**From:** FREGONESE, Victor <vxf@nei.org>  
**Sent:** Monday, July 10, 2017 11:30 AM  
**To:** Morton, Wendell  
**Cc:** Waters, Michael; Rahn, David; 'Archambo, Neil G'; AUSTGEN, Kati; HANSON, Jerud; REMER, Jason; Drake, Jason; FREGONESE, Victor  
**Subject:** [External\_Sender] RE: Upcoming RIS Meeting - Advance Discussions and Proposed Agenda  
**Attachments:** NRC Draft Regulatory Issue Summary 2017-XX Supplement to RIS 2002-22 - NEI Feedback for Public Meeting [7-10-17].docx

**NRC DRAFT REGULATORY ISSUE SUMMARY 2017-XX  
SUPPLEMENT TO RIS 2002-22**

## **Draft** Qualitative Assessment Framework

**Figure 1 - RIS Decision Tree Flowchart**

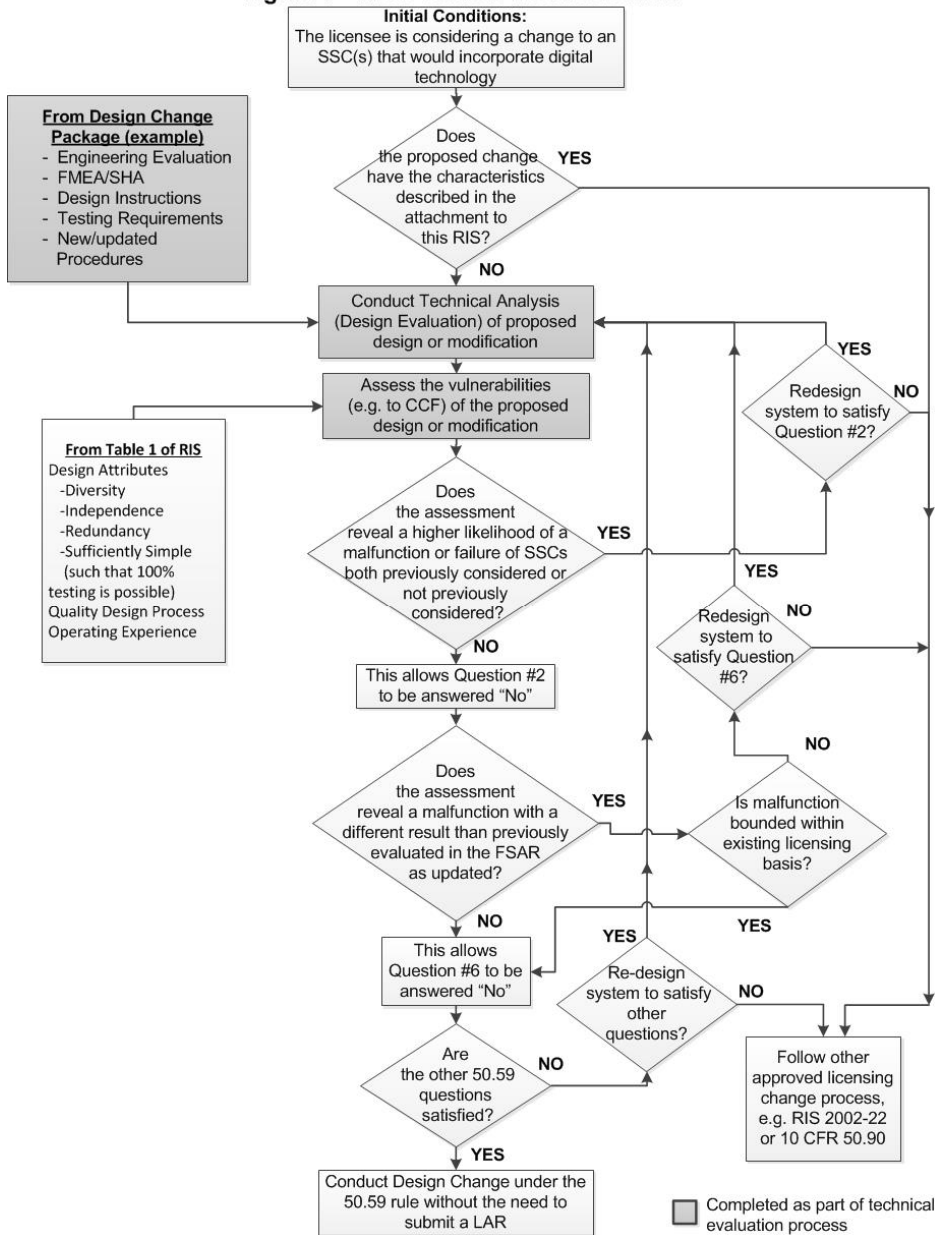
**Commented [NGA24]:** The first decision diamond asks "Does the proposed change have the characteristics described in the attachment to this RIS? Suggest being more specific by adding a specific section number of the RIS that details the characteristics. (RIS Section 3?)

Looks like the "Yes" and "No" decisions are reversed in this diamond - if the proposed change has the characteristics described in the RIS, shouldn't we then proceed to the Technical Evaluation?

Also noted that the flowchart only addresses 50.59 Evaluations Questions 2 and 6. Questions 1 and 5 do not appear to be addressed in the flowchart.
